## HISTORIC AND DESIGN REVIEW COMMISSION

September 06, 2017

**HDRC CASE NO:** 2017-443  
**ADDRESS:** 932 N PINE ST  
**LEGAL DESCRIPTION:** NCB 1653 BLK A LOT W 128.4 FT OF 1  
**ZONING:** R-5, H  
**CITY COUNCIL DIST.:** 2  
**DISTRICT:** Dignowity Hill Historic District  
**APPLICANT:** Juan Garcia  
**OWNER:** Juan Garcia  
**TYPE OF WORK:** Installation of composite porch decking  
**REQUEST:**

The applicant is requesting a Certificate of Appropriateness for approval to install composite decking on the front porch of the historic structure at 932 N Pine.

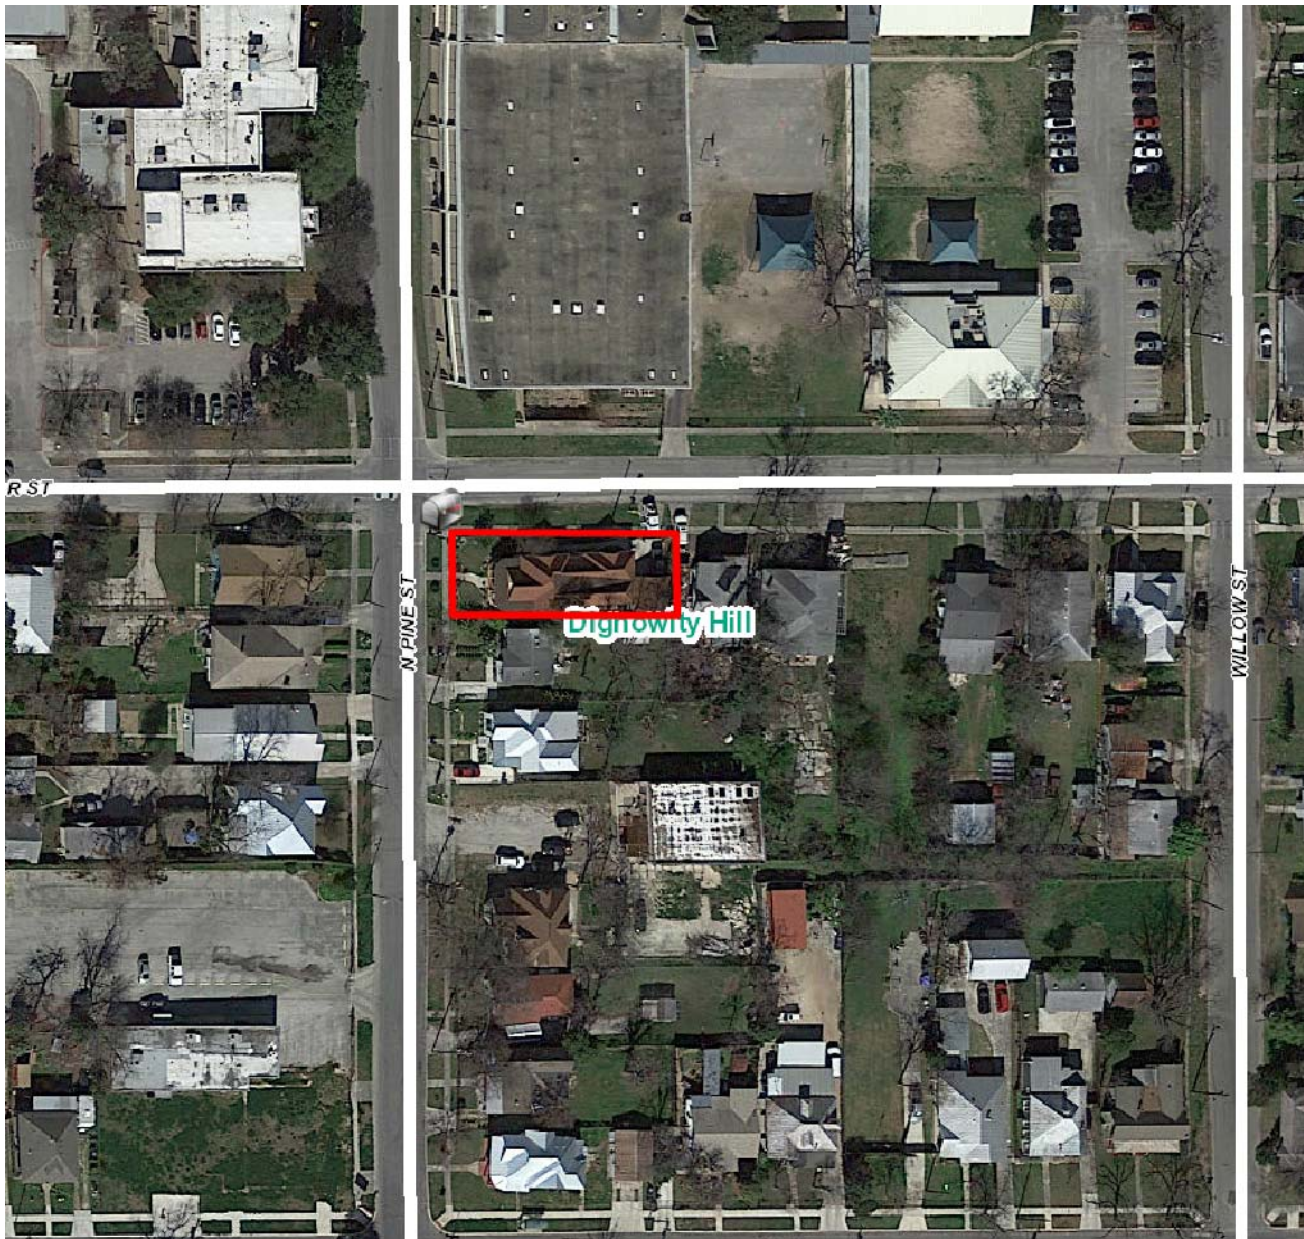
- a. The structure located at 932 N Pine Street was constructed circa 1910 and first appears on the 1912 Sanborn Map. The structure was constructed in the Queen Anne style. The structure features turned porch columns, spindle work, gabled and hipped roofs and a wraparound front porch. At this time, the applicant has proposed to replace the existing, wood porch decking with composite porch decking, the Aeratis product. The existing wood porch decking is not original and was installed during the recent reconstruction of the porch.

- b. The Guidelines for Exterior Maintenance and Alterations note that porch floors should be replaced in kind when deteriorated beyond repair. When in-kind replacement is not feasible, the new materials should match in color, texture, dimensions and finish. The applicant has proposed a composite decking product that features a profile that is consistent with that of historic porch decking. Staff finds the installation of a composite decking material appropriate.

Staff recommends approval as submitted based on findings a and b.
